SERVICE-INFO

Visual differences in the over-running alternator pulley 535 0218 10

Part no.: 535 0218 10

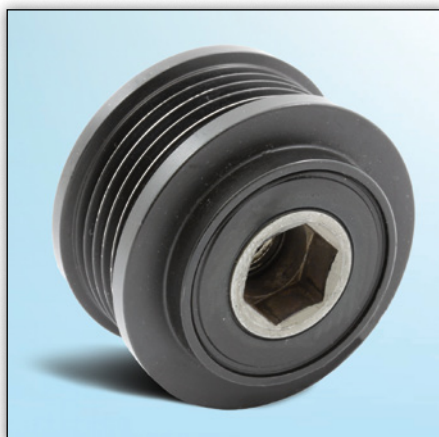
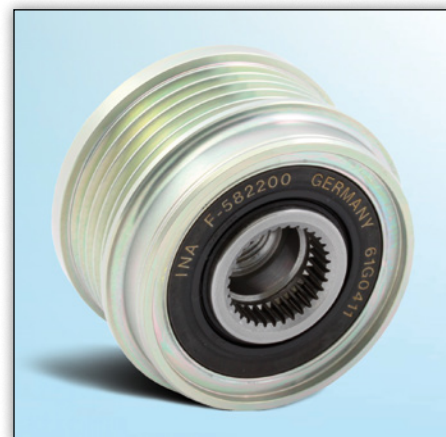
Two different over-running alternator pulley versions can be installed in the models mentioned above.

Image 1 shows the production over-running alternator pulley, which is installed by the corresponding vehicle manufacturer.

Image 2 shows the over-running alternator pulley offered by Schaeffler Automotive Aftermarket for the spare parts market.

The two over-running alternator pulleys fully comply with the technical requirements and only differ in their appearance.
